Figure 1: U.S. Class 4-8 Truck Sales and U.S. GDP Annual Growth Rate⁷⁵

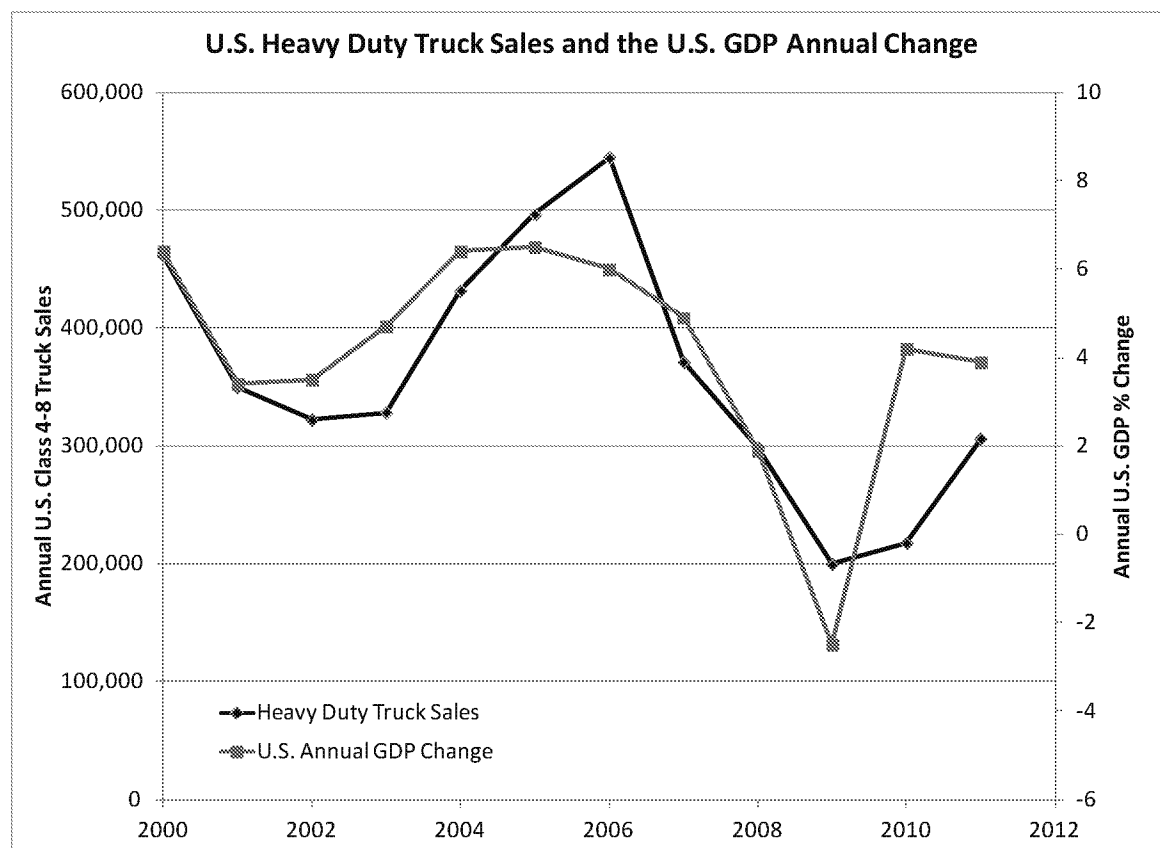
Finally, NADA's assertions that the 2004 and 2007/2010 heavy-duty emission standards caused the heavy-duty truck sales fluctuations over the past decade are mistaken. EPA believes that there are many factors that impact truck sales in any given year. For example, the American Trucking Associations develops the U.S. Freight Transportation Forecast based on factors such as the change in the U.S. gross domestic product, consumer confidence, housing, capital equipment purchases, government spending, imports and exports, bond yields, and truck capacity utilization.⁷³ Figure 1 below shows the annual sales of heavy-duty trucks (those with a gross vehicle weight rating of over 14,000 pounds) and the annual rate of change of the U.S. Gross Domestic Product (GDP) since 2000. Although the figure is not intended to imply causality, because other factors are expected to influence vehicle sales, it does provide an indication that factors such as the annual growth rate of the U.S. GDP may have an impact on truck sales.⁷⁴
